DRAWING NAME
6' [1829MM] WOOD FENCE

PROJECT NAME
ENTERPRISE RENT-A-CAR

Reviewed ()
 Reviewed as noted ()
 Review and resubmit ()
 Not reviewed ()

DRAWING NAME
WOOD GATE

DRAWN BY: AJL
DRAWING#: DH 02
DATE: May 4, 2020

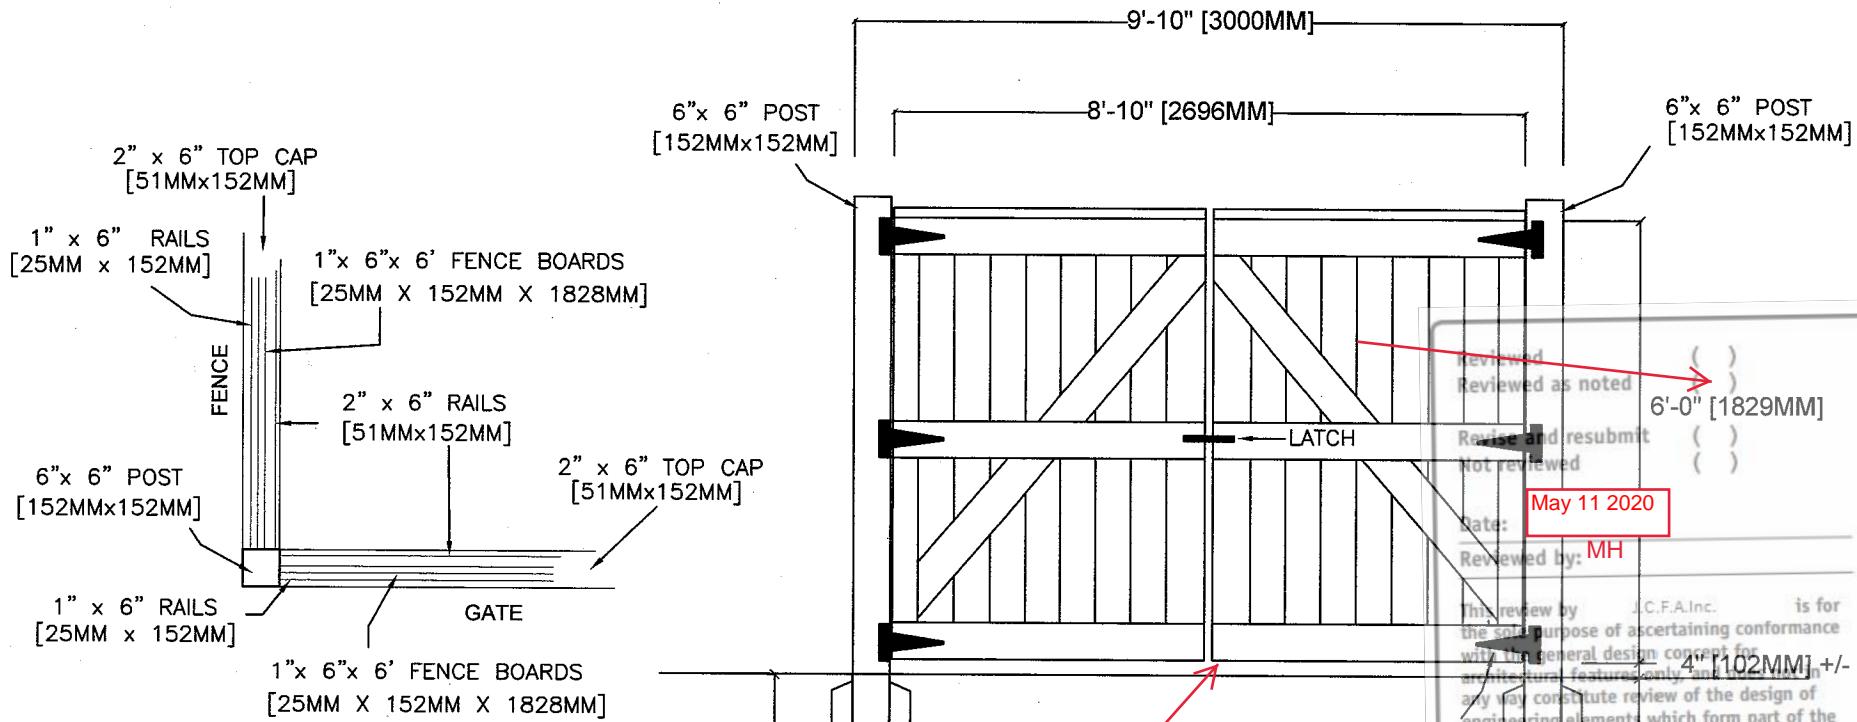
Should be 1500. Dwgs indicated 1350. Advise if extra cost.

Interior bollard required

Cane bolts and receivers and castors at slab.
